Project	IEEE 802.16 Broadband Wireless Access Working Group < http://ieee802.org/16 >	
Title	Clarification of the OFDM DL Subchannelization Zone	
Date Submitted	2005-06-07	
Source(s)	Fraser Cameron Wi-Lan Inc. 2891 Sunridge Way NE Calgary AB	Voice: (403) 204-7765 Fax: (403) 273-5100 fcameron@wi-lan.com
Re:	Sponsor Ballot Comment	
Abstract	This document proposes a clarification to the OFDM DL subchannelization zone	
Purpose	For consideration as a modification to D8 during Sponsor Ballot resolution.	
Notice	This document has been prepared to assist IEEE 802.16. It is offered as a basis for discussion and is not binding on the contributing individual(s) or organization(s). The material in this document is subject to change in form and content after further study. The contributor(s) reserve(s) the right to add, amend or withdraw material contained herein.	
Release	The contributor grants a free, irrevocable license to the IEEE to incorporate material contained in this contribution, and any modifications thereof, in the creation of an IEEE Standards publication; to copyright in the IEEE's name any IEEE Standards publication even though it may include portions of this contribution; and at

DL Sub-frame

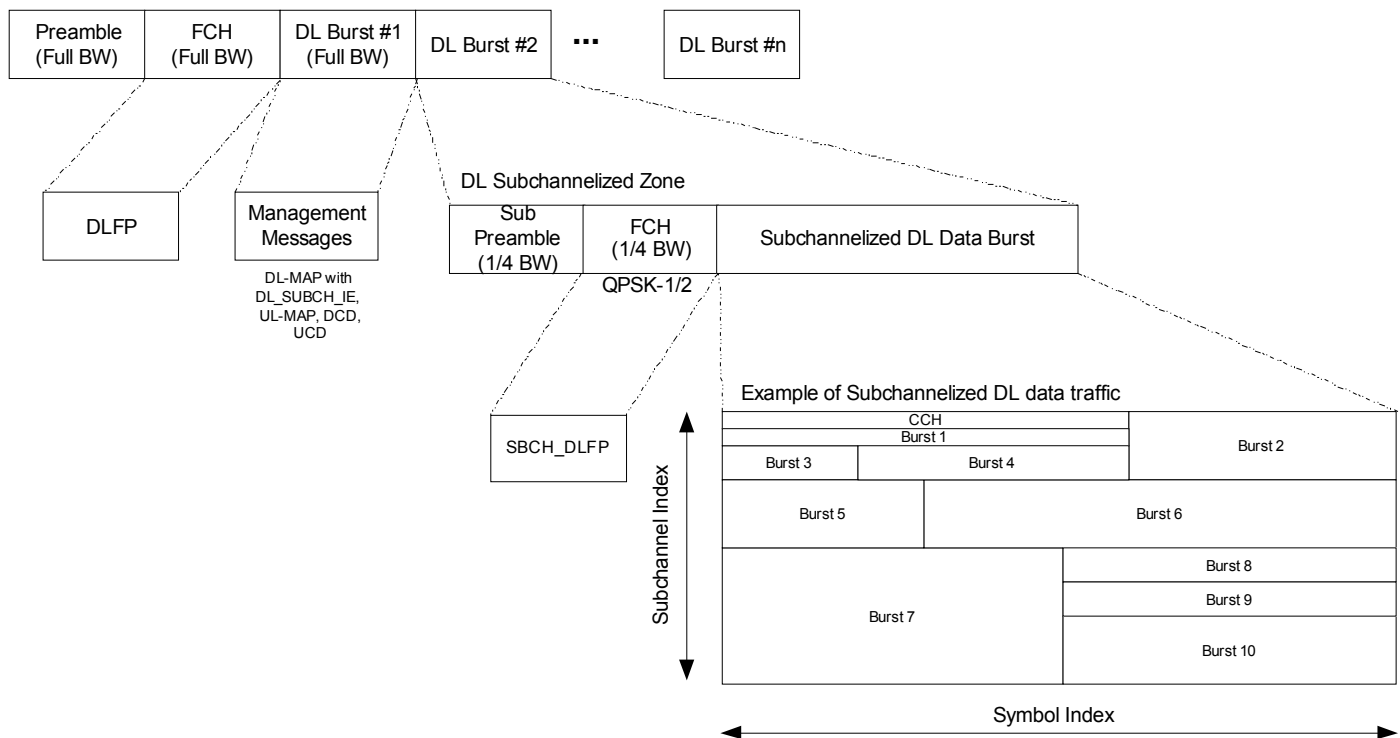
The figure from previous contribution IEEE C802.16e-05/093, the figure did not remove all of the ambiguities related to DL subchannelization, as it was not clear from the figure that the subchannelized DL data burst contained concurrent data bursts to multiple subscriber stations and how the control subchannel (CCH) should be used.

Replace figure 208a in section 8.3.5.1.1 with the following figure.

Modify Line 49 and 50 in page 244, section 8.3.5.1.1 as follows:

The CCH ~~may~~ shall carry ~~UL and~~ DL maps for bursts in the DL subchannelized zone. ~~UL maps shall use the format of UL_MAP_IE as in Table 243 (UL map IE)~~. The DL maps shall use the format ~~if~~ of SBCH_DL_MAP_IE as in Table 207d.
